SITE PLAN APPLICATION

9/13/21 Plan Commission Meeting

Village Planner Report

RE: Murphy Project Site at W206N12880 Gateway Court; Site Plan Review Application
Staff Review Comments

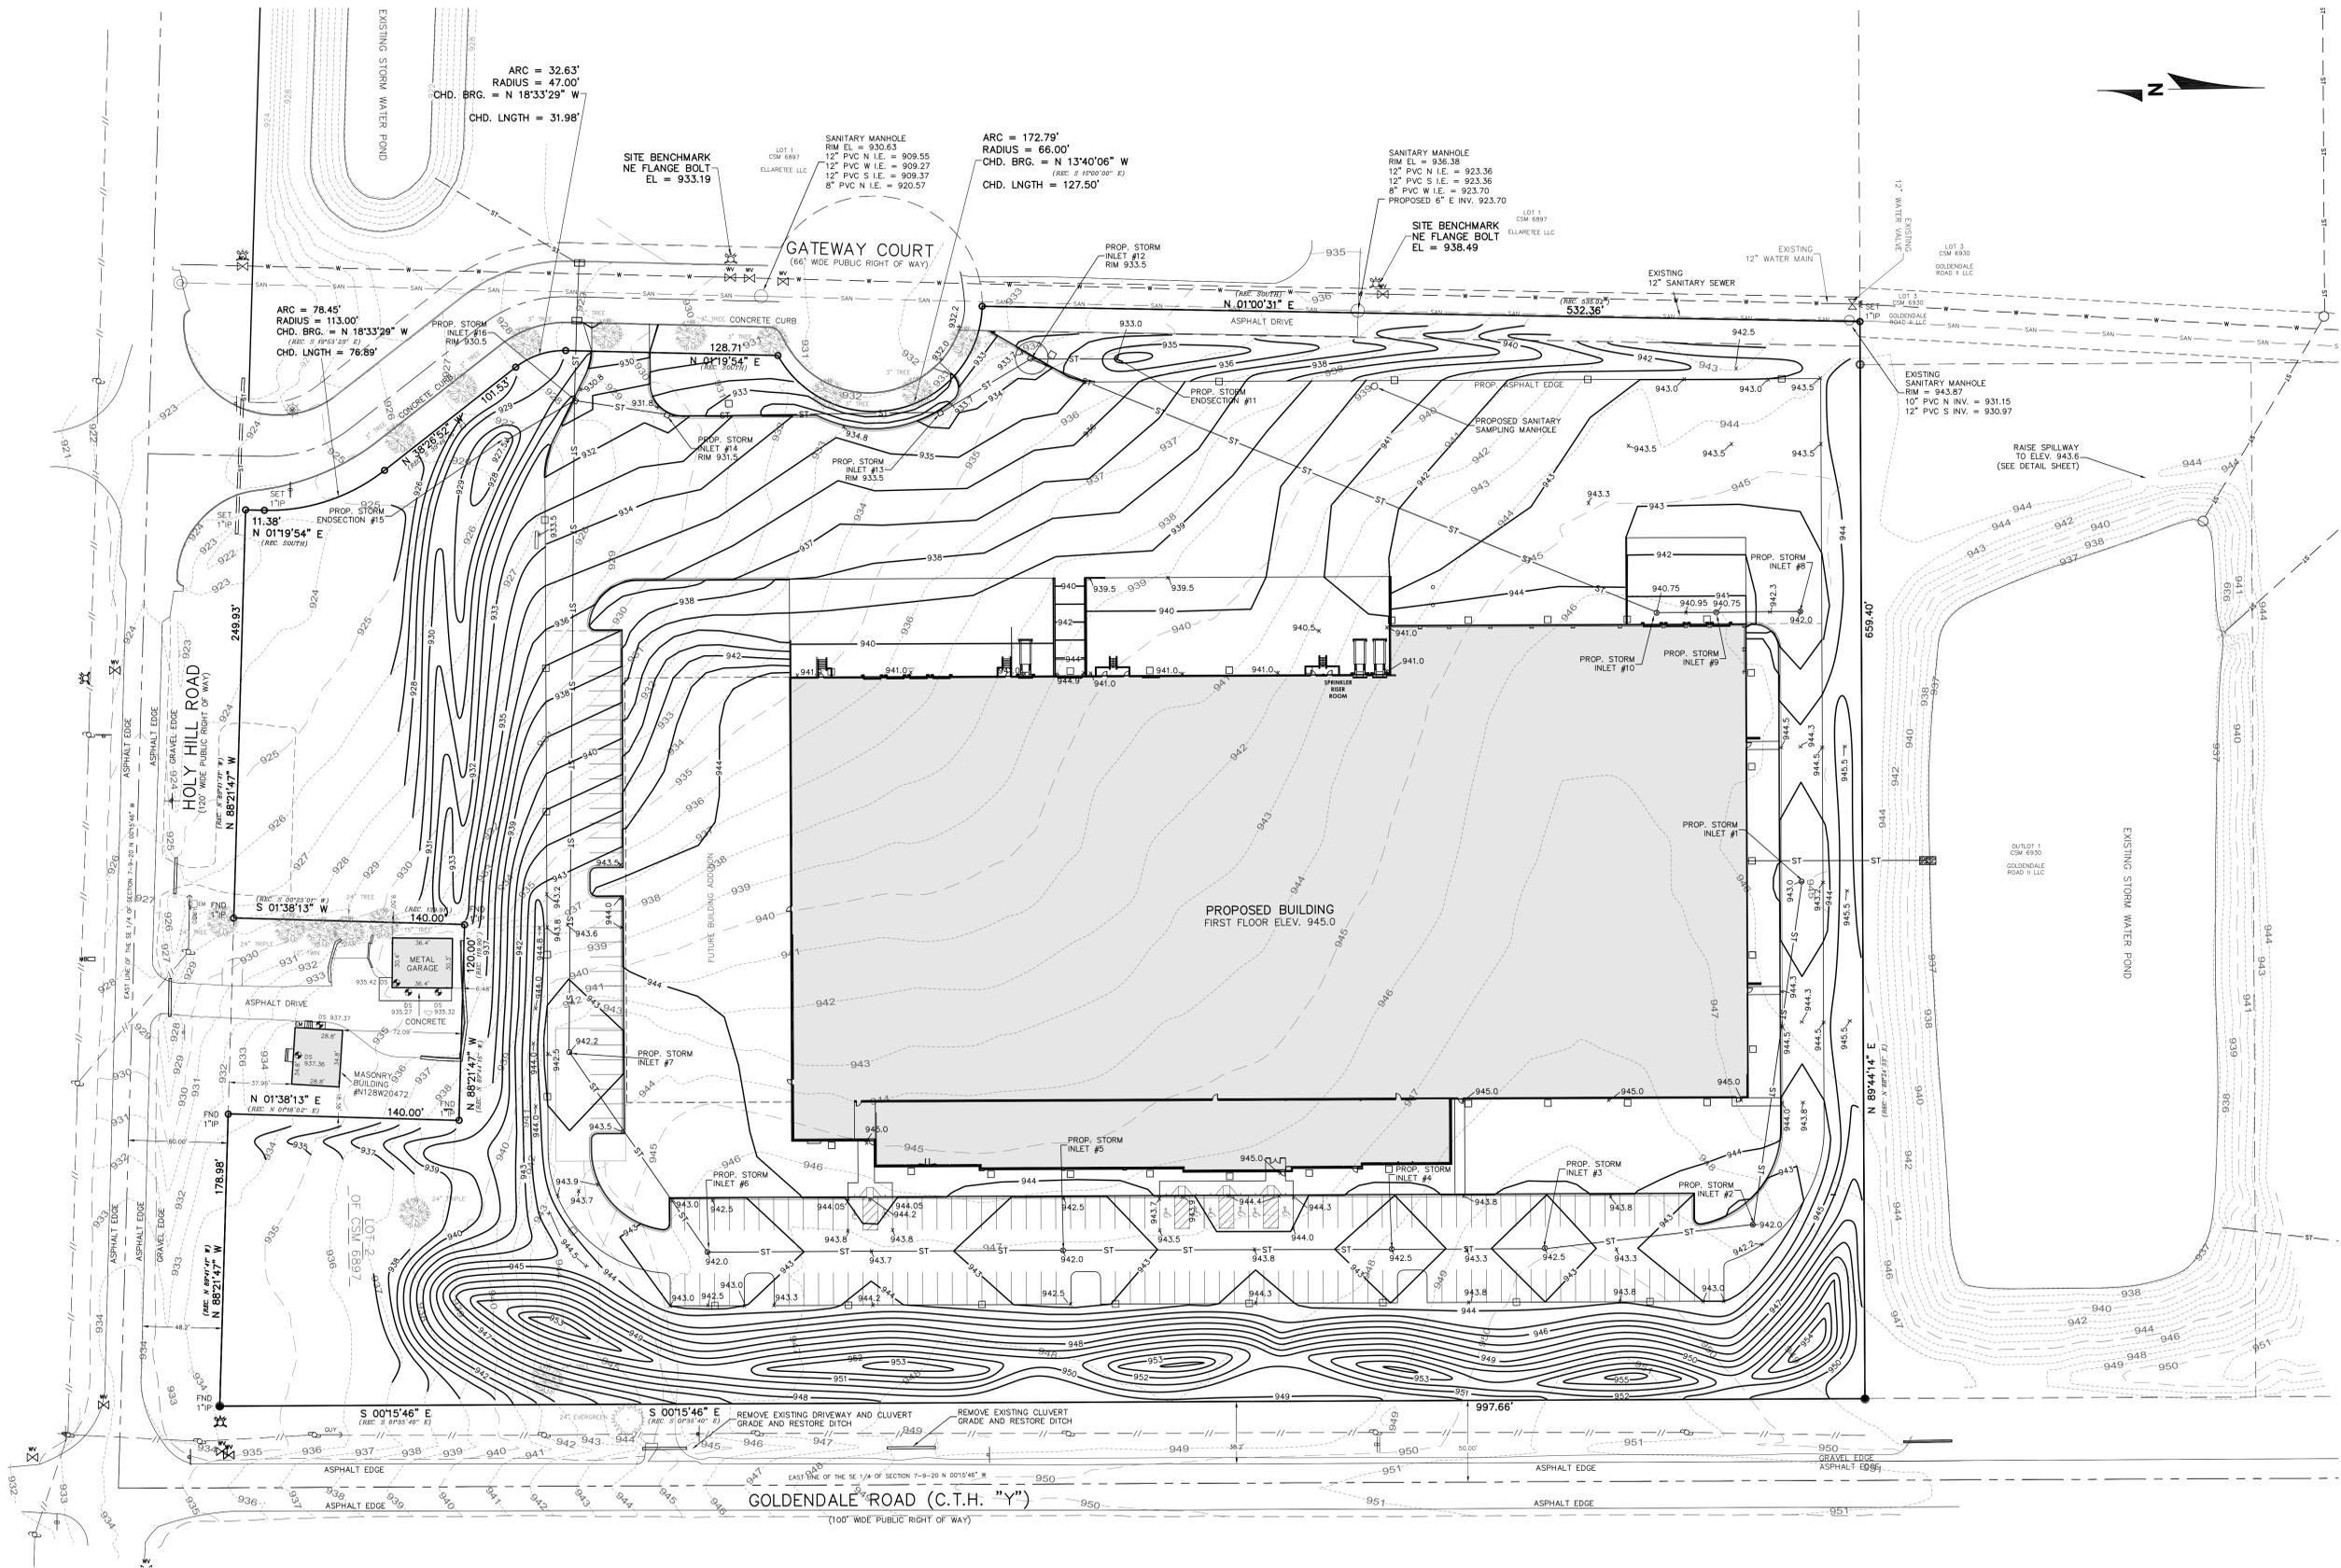
C2.0 Grading Plan

1. Show existing driveways and culverts along Goldendale road to be removed.

2. Proposed grading appears to direct additional runoff towards the remaining home on the south side of the project. Provide information showing that no additional water is being directed to that property and that there are no negative drainage impacts to that property.

3. The eastern portion of the site overflows directly towards the remaining home on the south side of the site. This must be revised to have the site overflow away this home and towards to the stormwater basin.

4. Provide additional spot elevations to evaluate drainage.

5. Plan proposes 20" of ponding in paved areas prior to overtopping. Revise to a max ponding depth of 12 in paved areas.

6. Portions of the northern drive overtop to the stormwater basin to the north, but storm sewer routes the smaller events south. Revise grading and storm sewer to route all storm events to the same basins. *The storm sewer system has been sized for the 100-year design storm event to ensure that the runoff get to the existing storm water ponds, conforming with the storm water management plan.*

8. Plans proposed raising the grade in the ROW near an existing overhead power line. Provide documentation that WE-Energies is accepting of this grade change near their lines.

9. Show overflow routes through the site with large bold arrows.

This has been noted on the plan.

Additional spot elevations have been added to the plan.

The grading and storm sewer has been revised to eliminate most of the bypass.

The grading has been revised, removing any grading in the right-of-way or near the overhead power lines.

C3.0 Site Utility Plan

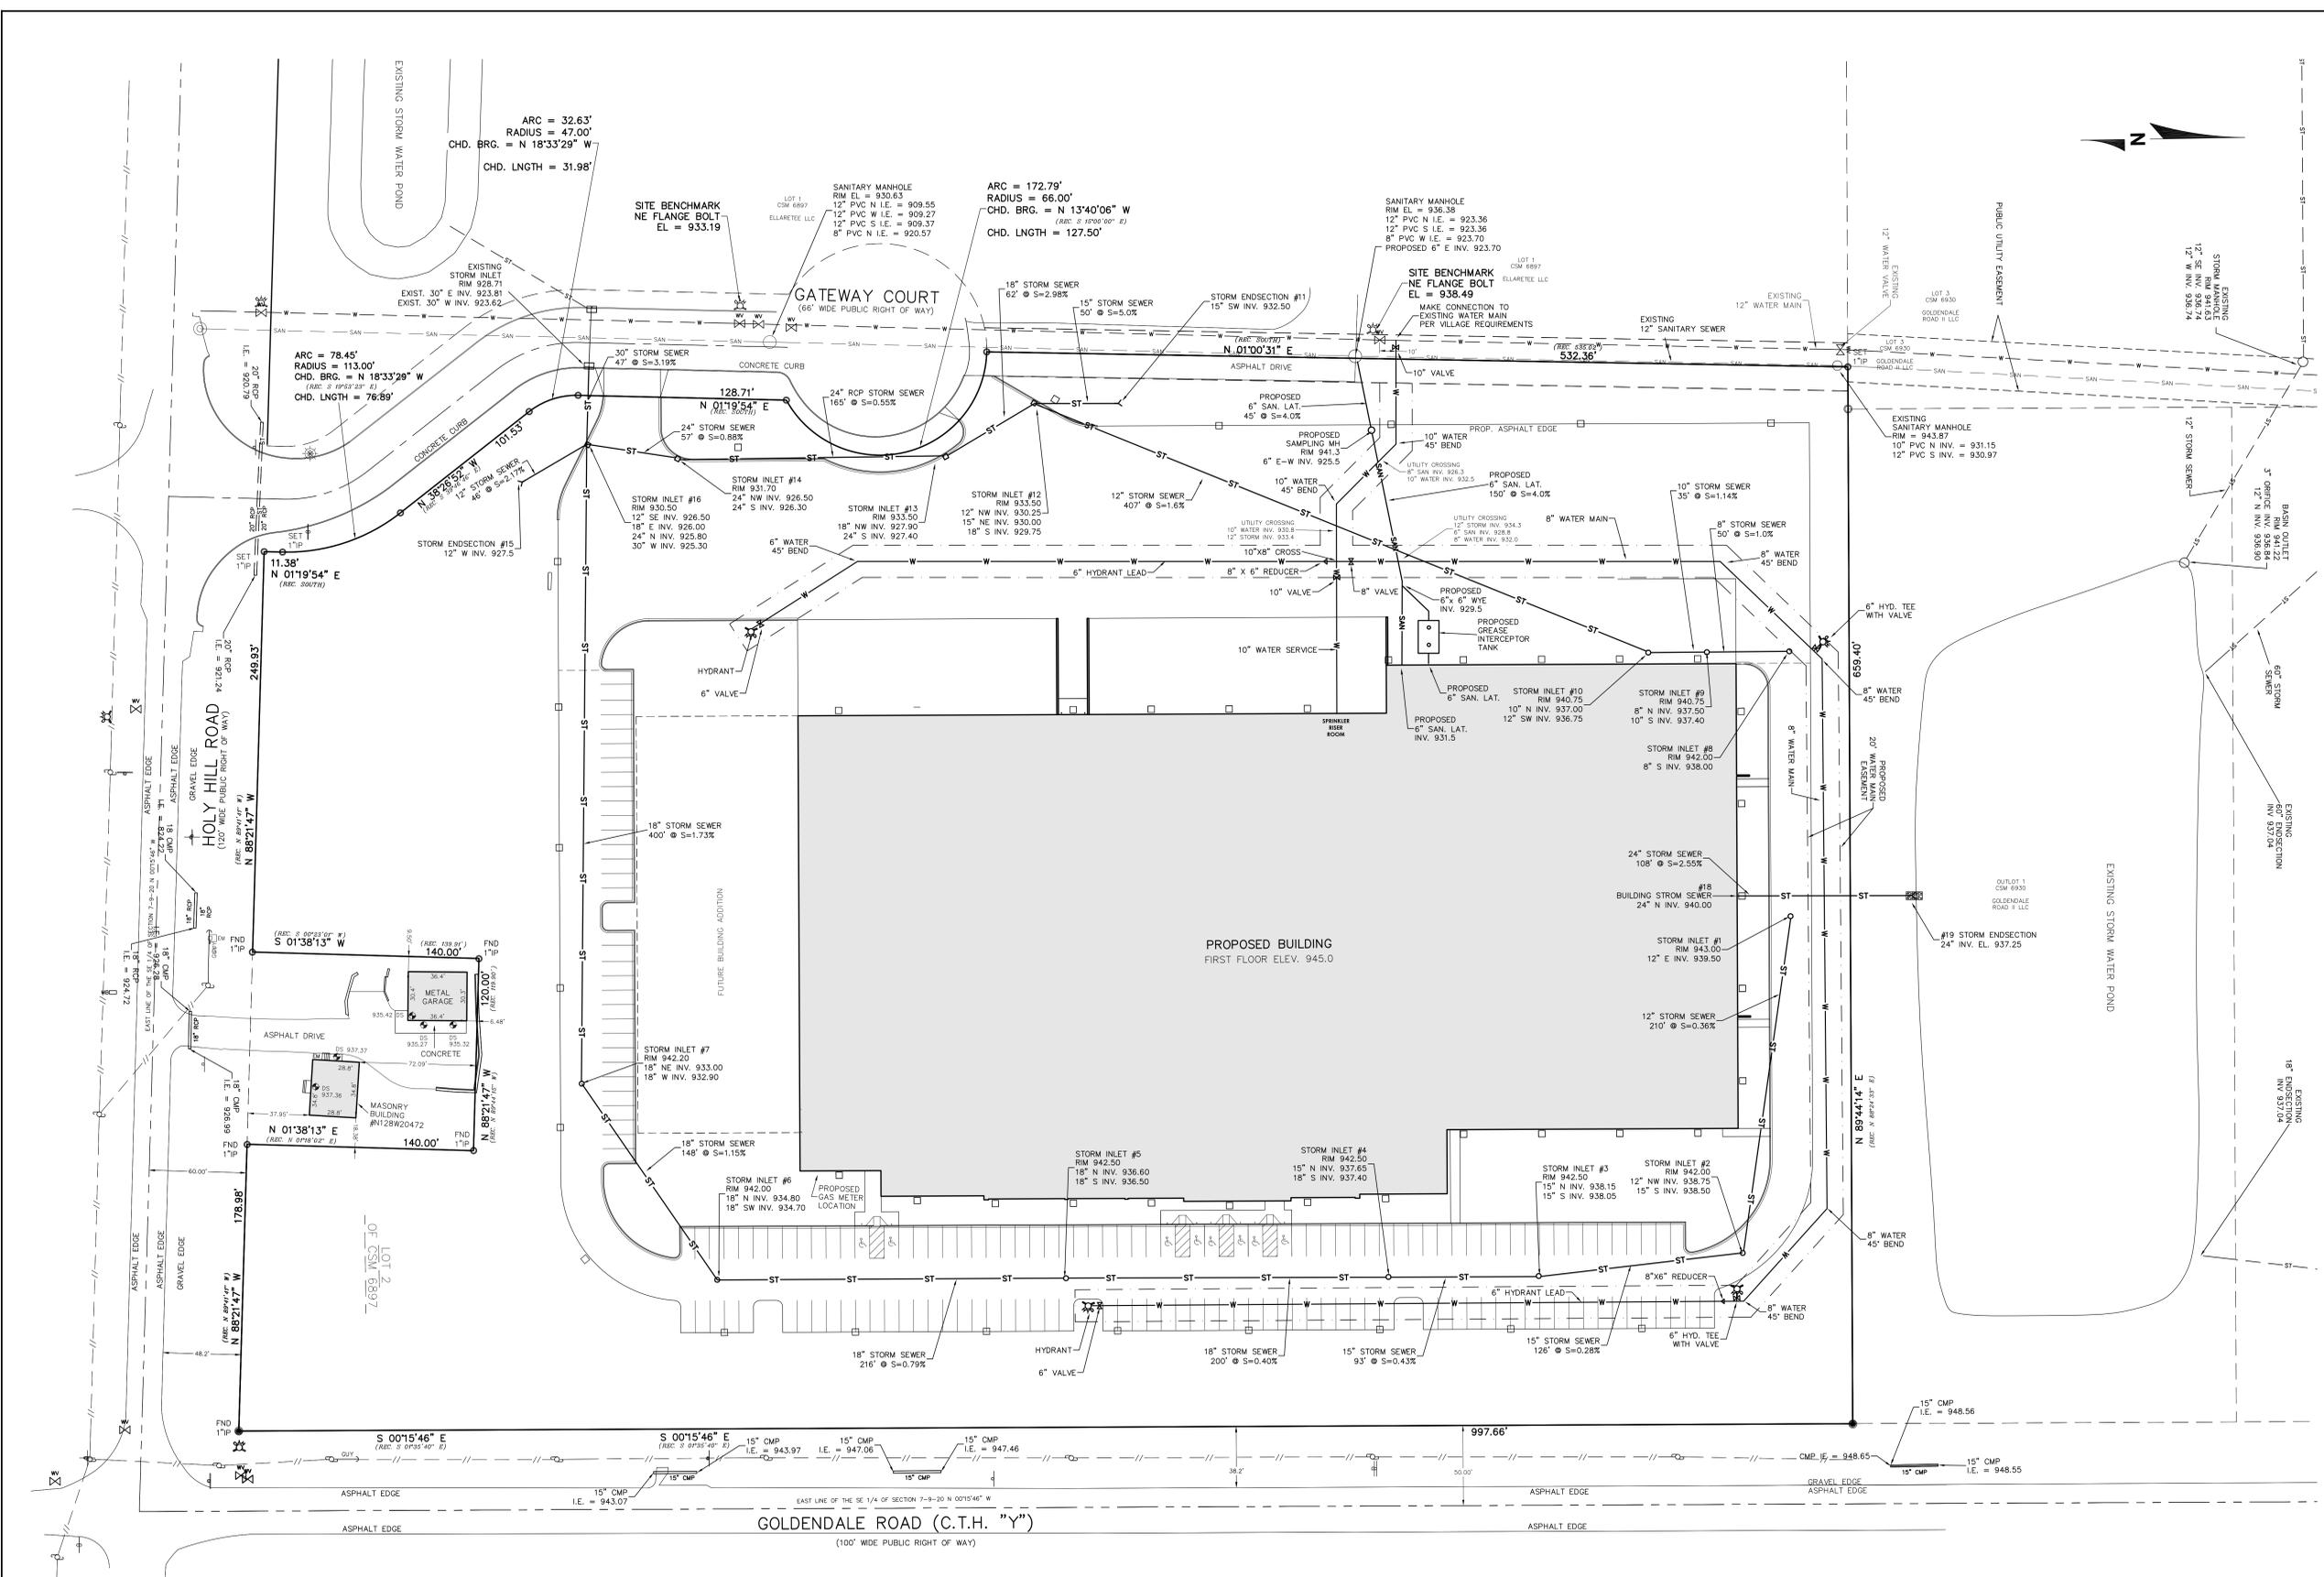
- The hydrants that wrap around the north side, south and east need to be marked PUBLIC to include an easement.

- At the hydrant leg that goes south connect this by a 4-way to the hydrant leg to the north. Also add a 10" gate valve east of this new 4-way with a 5' separation but also it needs to be west out from the building and 15' from any concrete hardscaping.

1. Connect Sanitary directly into SA 07-015 at an elevation of 921.40, show on plan

1. If inlets are used instead of catch basins provide a minimum of 0.10' drop across the structure.
The minimum drop has been incorporate into the revised storm sewer design.
2. Provide storm sewer calcs, including an exhibit showing drainage areas to each inlet.
Enclosed are the storm sewer calculations and drainage area plan.

Understood – the proposed easement for the public hydrants and water main is shown on the revised utility plan.

The water connection has been revised as directed.

We have moved the sewer connection to connect directly into the MH. Based on the surveyed invert grades we are proposing to connect at elevation 923.70 (see sheet C3.0)
